Title:	RN DS-K1T671 Series MinMoe Terminal	Version:	v3.1.0	Date:	042120
Product:	DS-K1T671 MinMoe Terminal	Build:	200420	Page:	1 of 5
Action Required:	None, Information Only

Firmware has been upgraded to add new features, fix bugs, enhance product quality, and meet customers' requirements.

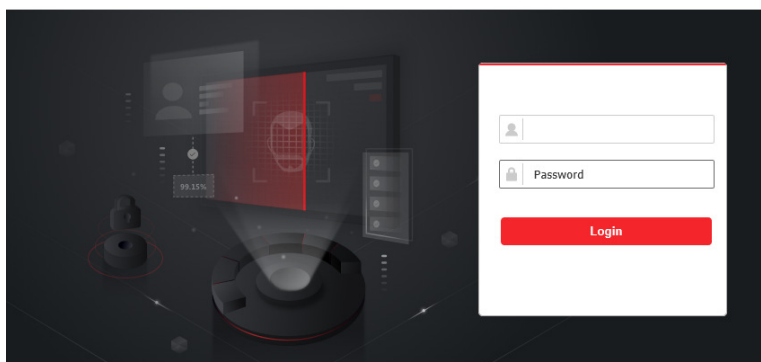
- Log in and configure device in Web client via Web browser to realize person management, parameter configuration, log search, and system maintenance.

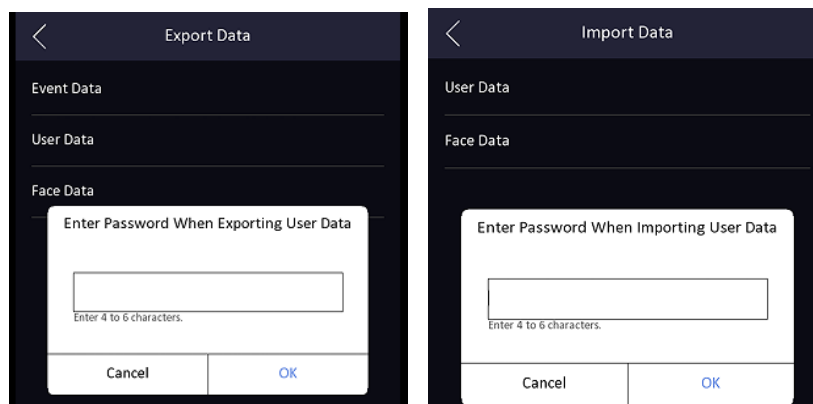
- Supports encryption (4 to 6 characters, optional) for USB import and export data.

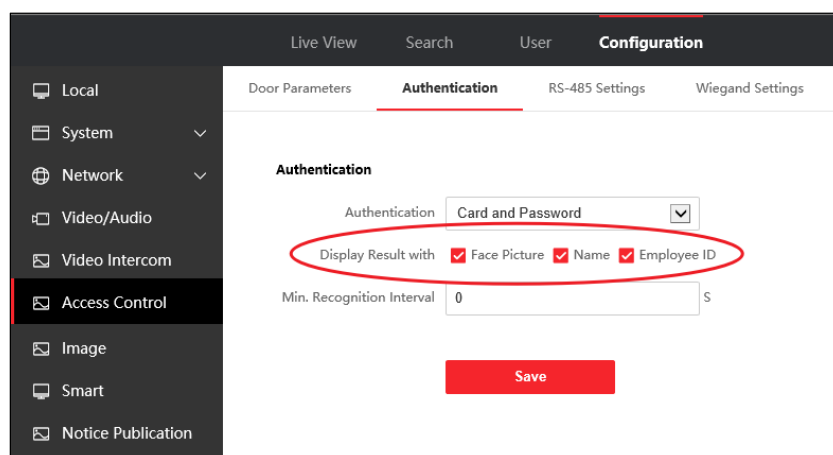
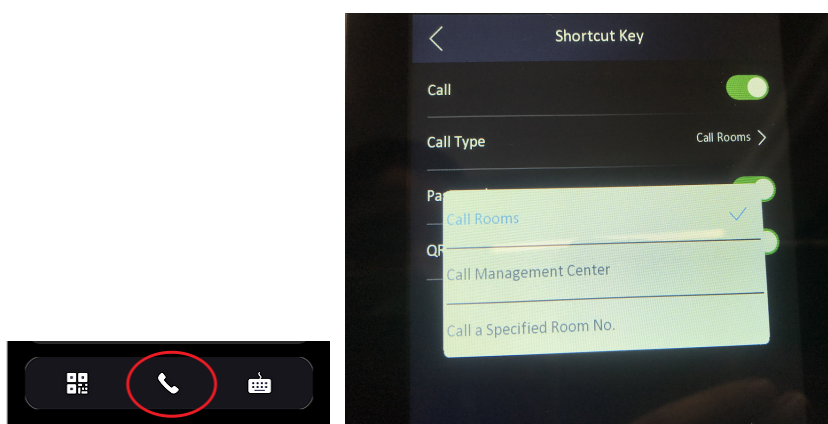
- Self-defined screen display info (user ID, name, and face picture) for authentication result.

- Self-defined shortcut key (QR Code, Call, and Password) on main interface, with which a user can select to call rooms, call Management Center, or a specified room number after pressing the call button on the main screen. Can call a specified room no. by default.

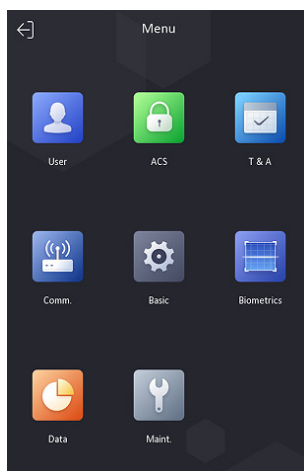
- Optimized new UI style
